Horsham
District
Council

HORSHAM DISTRICT COUNCIL CONSULTATION

TO:	Horsham District Council – Planning Dept
LOCATION:	New Place Nurseries London Road Pulborough West Sussex
DESCRIPTION:	Reserved Matters application pursuant to Outline Planning Consent DC/21/2321, as varied by application DC/24/1204. The Reserved Matters comprise details of 160 no dwellings, associated internal access roads, parking and landscaping for areas east of the right of way. Details of appearance, landscaping, layout and scale to be considered.
REFERENCE:	DC/24/1676
RE-CONSULT:	1 st set of comments in black 2 nd set of comments in blue 3 rd set of comments in green
RECOMMENDATION:	Objection / More Information / Modification Objection / More Information / Modification Objection

3rd set of comments

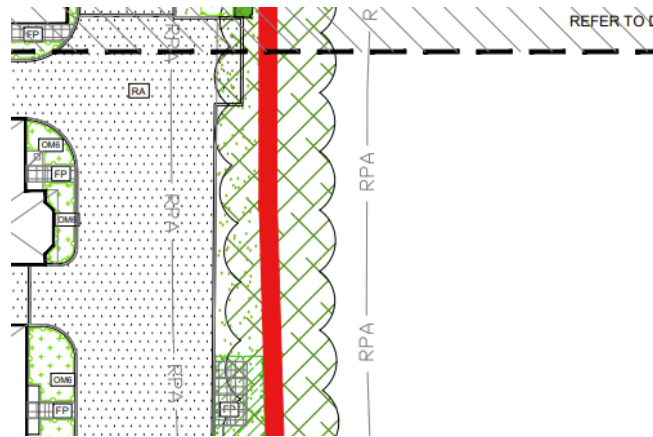
We consider this narrowing to be significant, as opposed to slight [see design evolution below]. The previously approved corridor shape reinforced the countryside character by virtue of a wide cone absent from development, positively contributing to the long distance views and thus recreational enjoyment of users of the PRow. The newly proposed built form within this cone creates short and medium distance views that while unlikely to fully block views of the SDNP, detracts from the sense of place and the countryside setting. We request that framework plan is amended to that previously approved or further consideration made in order to meet aims and objectives as cited above.

If this is disagreed with, we request a verified photomontage of the proposals from EDP LVA Viewpoint 2/ Finc Viewpoint 1 to demonstrate that the long distance views are retained and enhanced.

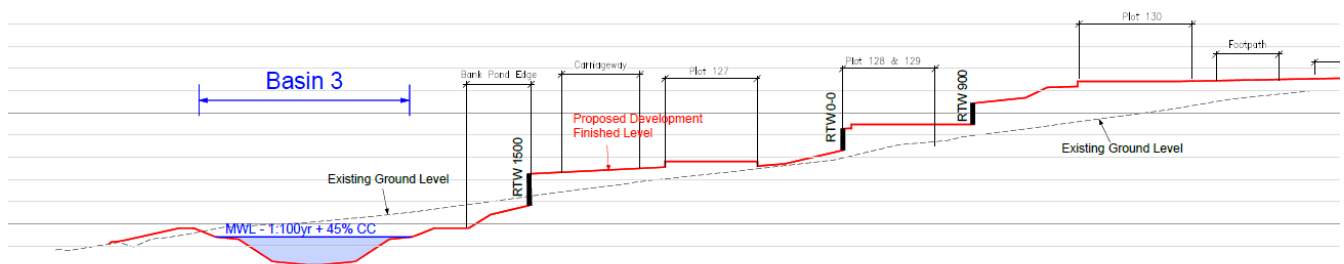
15. Plan demonstrating coordination of landscape proposals, tree planting, underground services and lighting. We note that the main avenue of trees is included within drainage proposals, however there are discrepancies with this and the landscaping proposals. Notwithstanding this, the entire tree scheme must be reflected.

Not addressed.

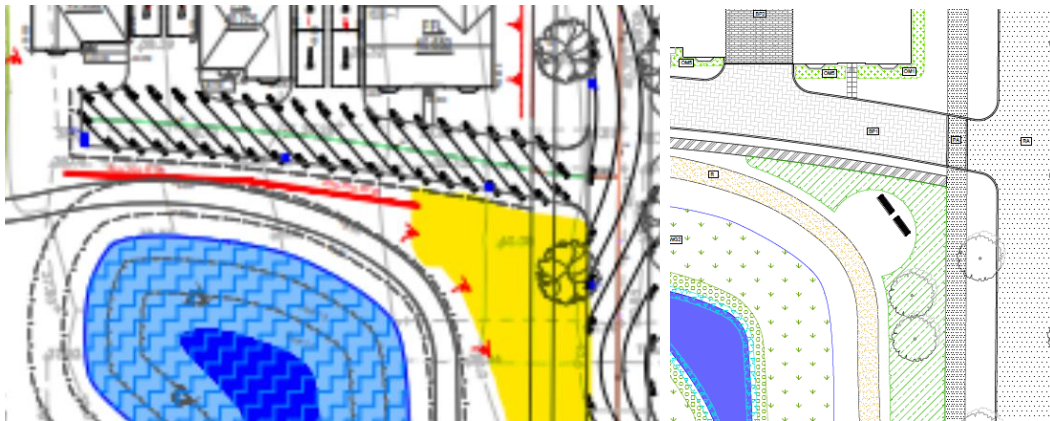
17. We highlight for example the retaining walls to the north of each attenuation pond. 1.5m drops is of concern and would require balustrades to be added. All of these highly engineered interventions do not lead to sensitive design or a landscape led scheme.

We note 1.5m drops remain. As above, it is imperative that these are reduced or removed entirely to ensure a sensitive design. Please see point 42 for further comments.

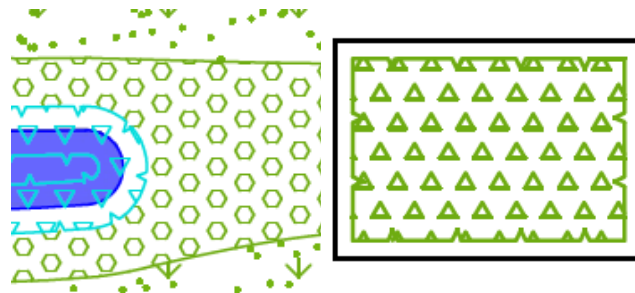
21. North-south tree lines such as G18 are proposed to be removed in Arboricultural plans, however these are shown as 'Existing trees / vegetation retained' in the Landscape Masterplan/ approved parameter plan. As above, the Landscaping Proposals do not cover this area, therefore further information is required to be submitted. We request that these are retained as they're seen as key structural feature that positively contributes to the landscape framework and to embed the scheme into the landscape.

We note the updated AIA which details, '*Poplar collection to be repollarded (to previous pruning points) components with excessively decayed boles to be removed*'. In order to ensure the longevity of this landscape feature and enhance it in line with the approved development objectives, we request that every removed tree is replaced with a species listed under 'Native Parkland Trees' within the Plant Schedule. Please include details within the landscape plans and planting schedule.

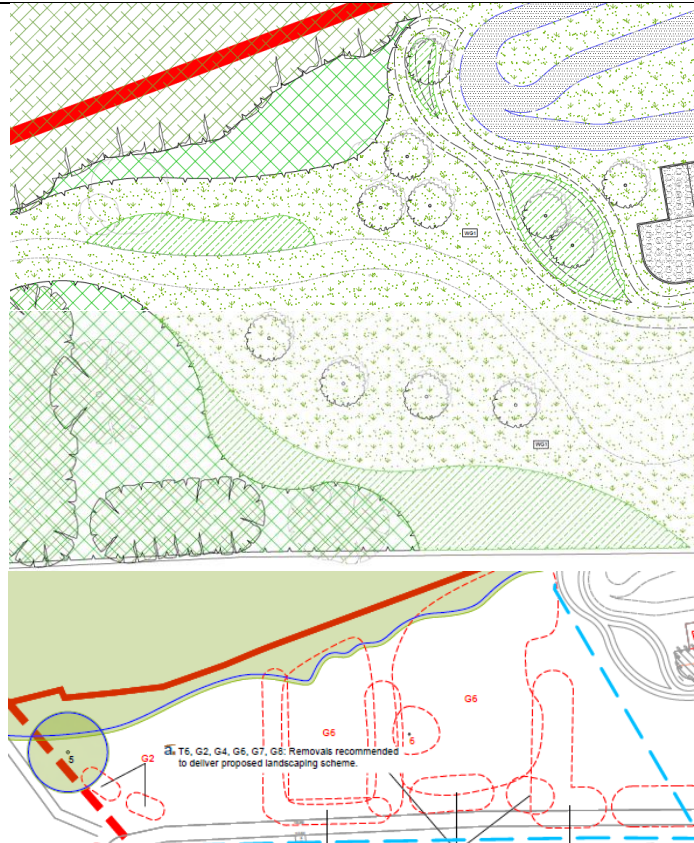
24. Clarification is requested in regard to the hexagonal hatch [below, left] which does not appear in the legend, and if it is meant to indicate reedbed [below, right].

Hatch updated. Closed.

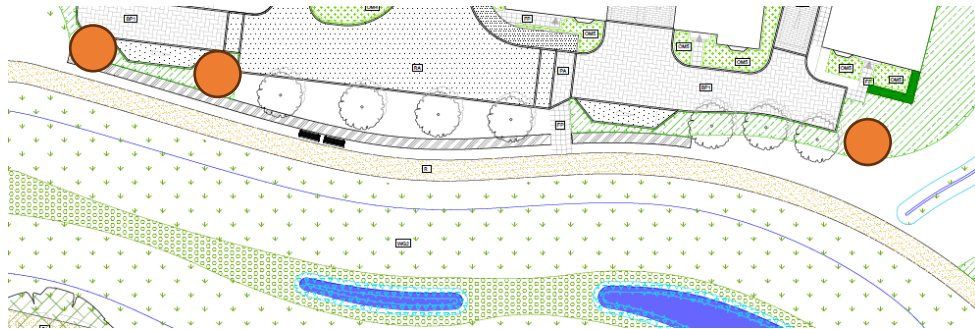
29. We note that some areas on the eastern boundary appear to be left clear of planting – see examples below. Given that our comments under PE/24/0081 and DC/21 both state to pull, 'the built form edge away from the eastern boundary to introduce woodland shaw / belt planting of native species', we continue to recommend that these areas are densely planted to assist the transition into rural countryside.

Layout has changed – see point 14. Closed.

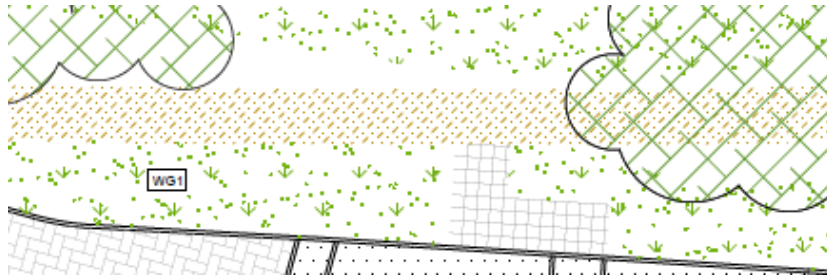
- d. Entrance feature

Not addressed.

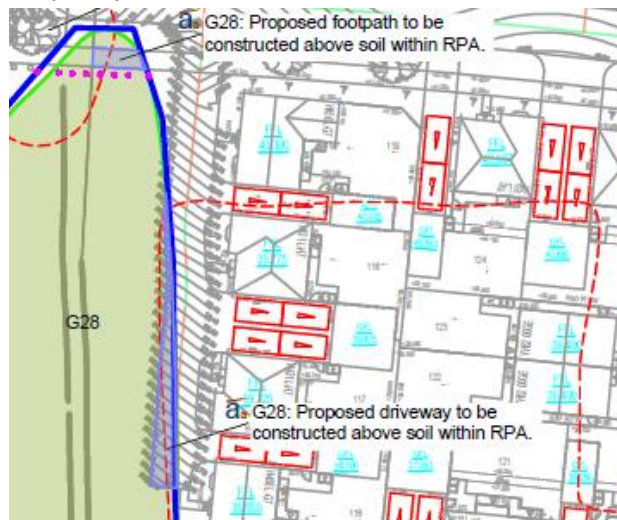
33. We recommend amending the flag paving in this location [below] to be informal path, which is more suitable for the surrounding context.

Layout has changed. Closed.

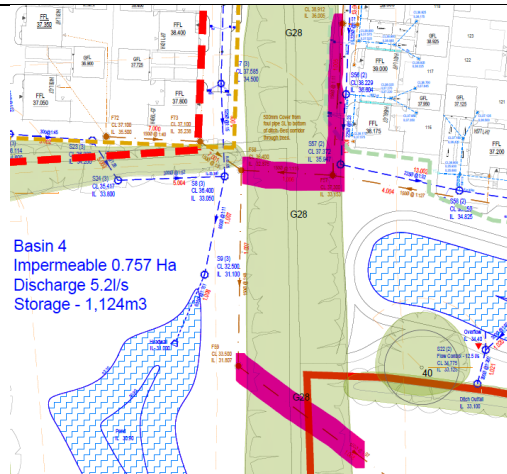
- a. Of key concern is aforementioned Category A G28, where multiple drainage paths are proposed [highlighted in pink, below]. We recommend that drainage avoids the RPAs of G28 entirely and that other routes are explored. If it can be demonstrated that there is no alternative option but to encroach G28, only one drainage trench should be proposed at minimum and advice from the HDC Arboriculturist should be sought in order to minimise adverse effects.

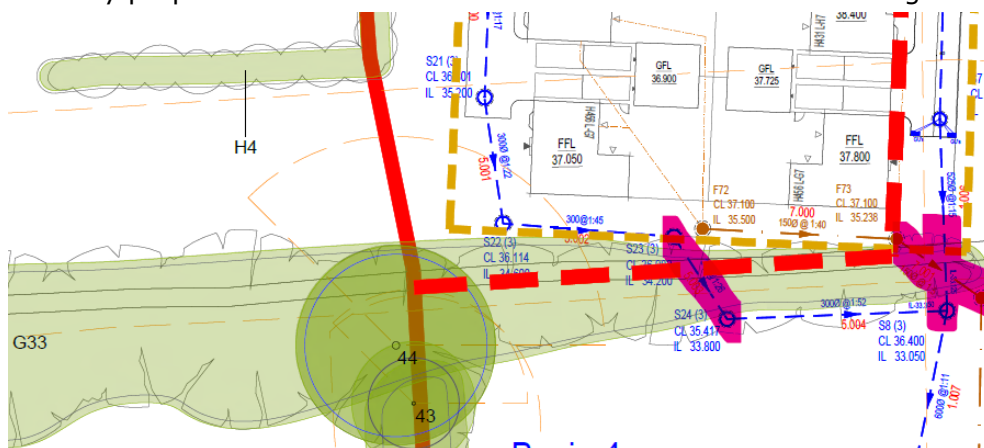
While it is welcomed that the southern drainage run has been removed, the northern run remains [highlighted in pink, below]. Given that the foul run no longer connects to the western parcel, we request that it is removed entirely to avoid Category A G28.

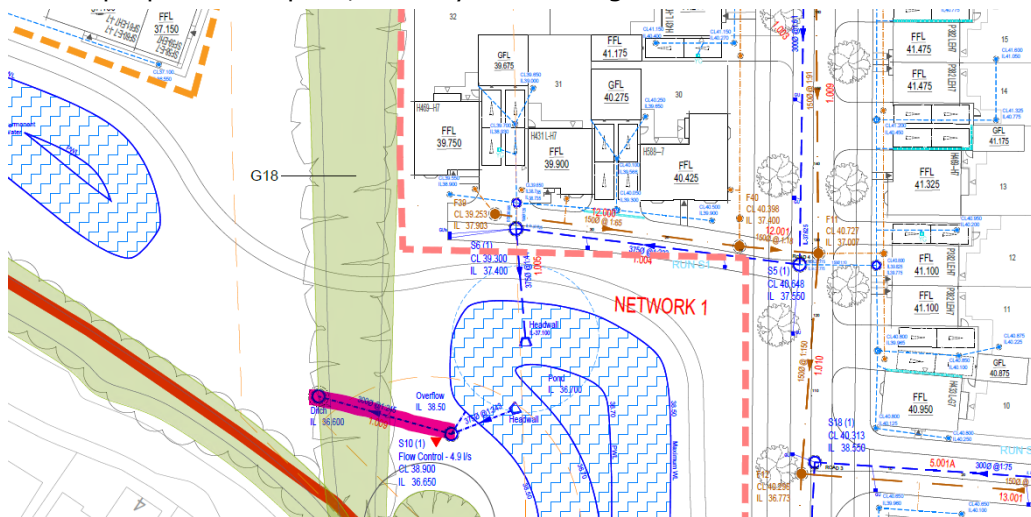
- b. As above, multiple drainage routes pass through G33 [highlighted in pink, below]. While this group of trees is of lesser quality than G28, it still positively contributes to the character of the area, therefore should be retained and safeguarded. Please modify proposals to avoid and minimise disturbance to the rooting medium.

While one route has been removed, with thanks, further routes remain [highlighted in pink, below] and the updated orientation will cause further conflict with G33 and associated RPAs. As previously requested, please modify proposals to avoid and minimise disturbance to the trees and rooting medium.

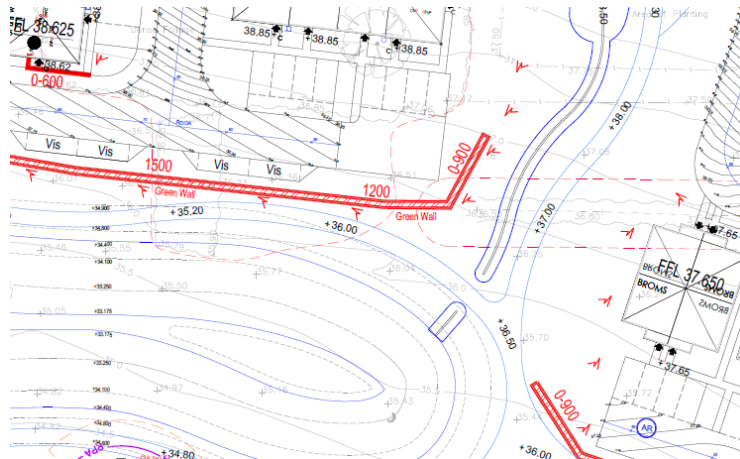
37. Please submit a land budget plan demonstrating sizes, buffer zones and walking distances. We echo comments made on 03/04/2025 by HDC Parks and Countryside, particularly in regard to the 20m buffer zone as the proposed location of the LEAP does not appear to meet this criterion. We recommend that Horsham District Council's *Open Space, Sports & Recreation Review 2021* (OSSR) is referred to for guidance.
38. As per our previous comments, BMX dirt and earth tracks should meet the requirements of the RoSPA safety guidelines (approved by British Cycling) and designed by bike track experts to integrate organically into the green space, using planting and different forms of features to create a sense of place. We expect:

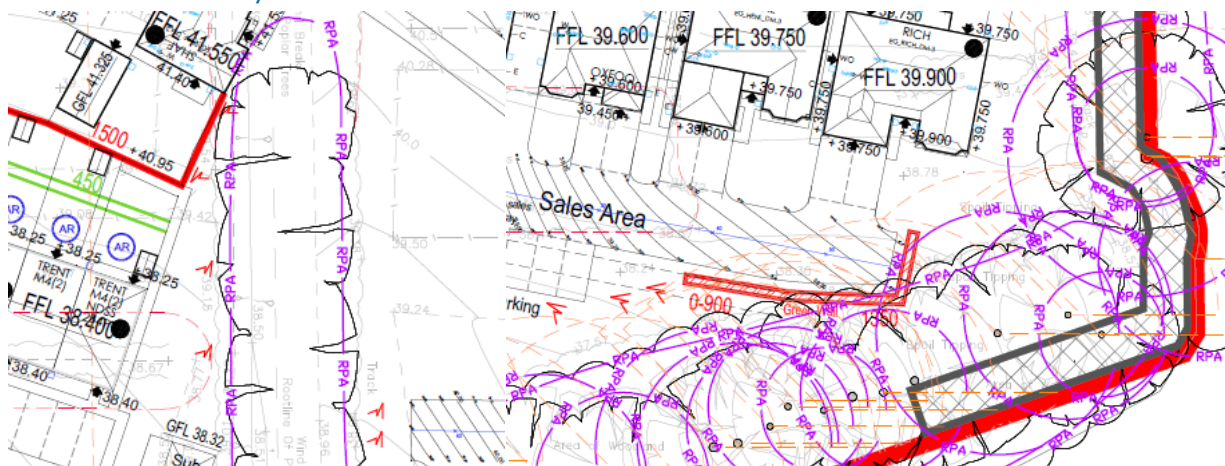
39. As per point 18, the levels plan remains unclear. Contour lines and gradients are required to ensure the suitability of scheme. We highlight the slopes indicated below.

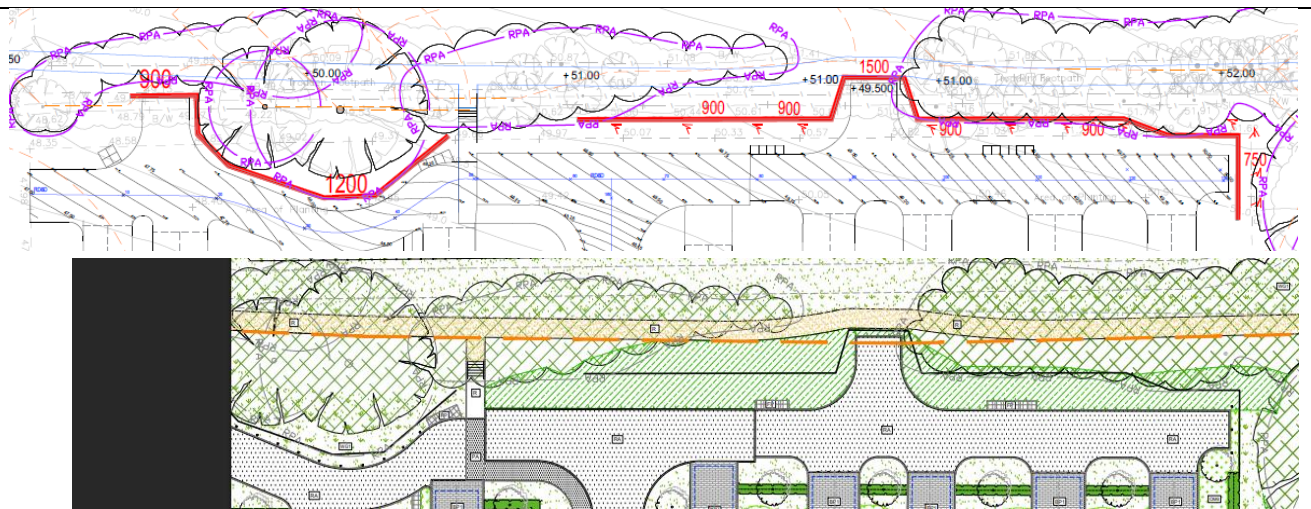
40. Further, we note multiple instances of 'green wall' in place of a retaining wall. Clarification is requested.
41. Please note that RPAs should be clear of mounding/earthworks as sufficient oxygen levels are essential for their long-term retention. The loss of these trees would result in adverse effects to the landscape character and amenity of the area, thus their longevity should be secured. As such, and as previously requested, existing and proposed contour lines are requested to understand the effects of earthworks on existing landscape features. Please see areas of key concern below:

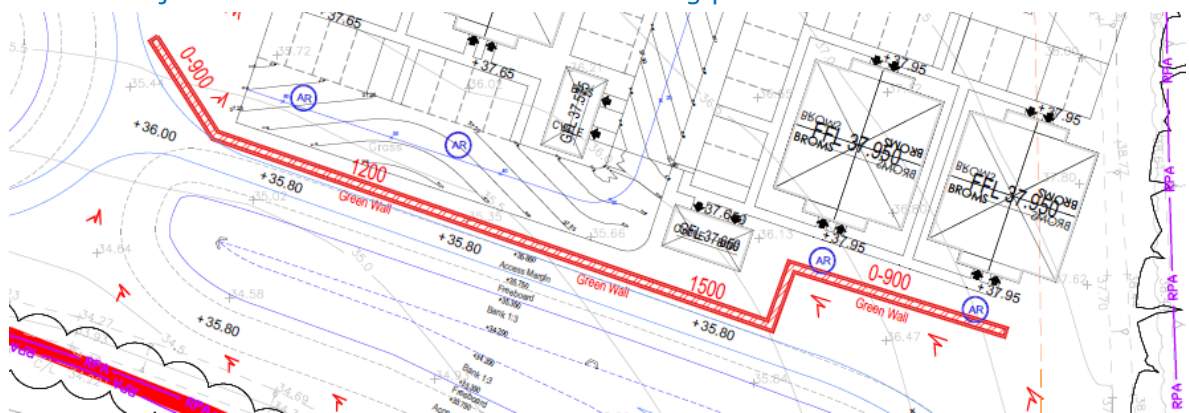
42. As previously commented, concern is raised in regard to drops of 1.5m and would require balustrades to be added. We note further instances of these drops on account of the changes to proposals, two of which are highlighted below as unacceptable:
 - a. Adjacent to the PRoW

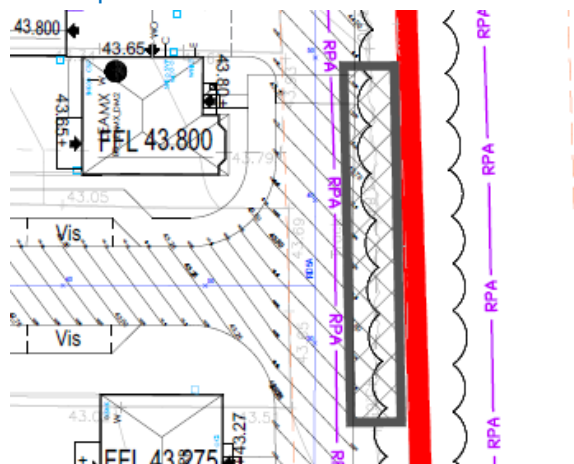
b. Adjacent to an attenuation basin indicating permanent water levels

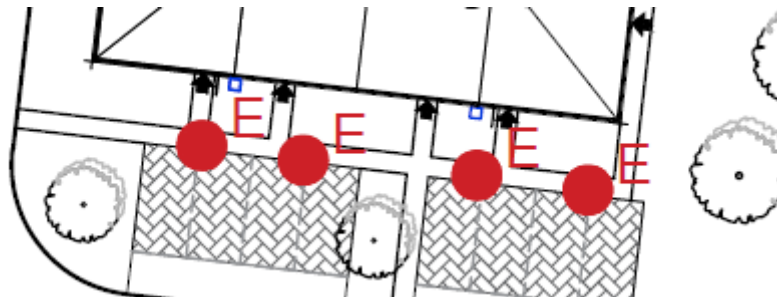
44. We note further inconsistency in plans. The central treeline is retained within the masterplan [below, left] and partially removed in the Tree Protection Plan [below, right]. As previously commented, no Combined Hard and Soft Landscape Plans have been provided for this area. We request clarification and that plans are updated for consistency, noting that any removed trees should be replaced, as per point 21.
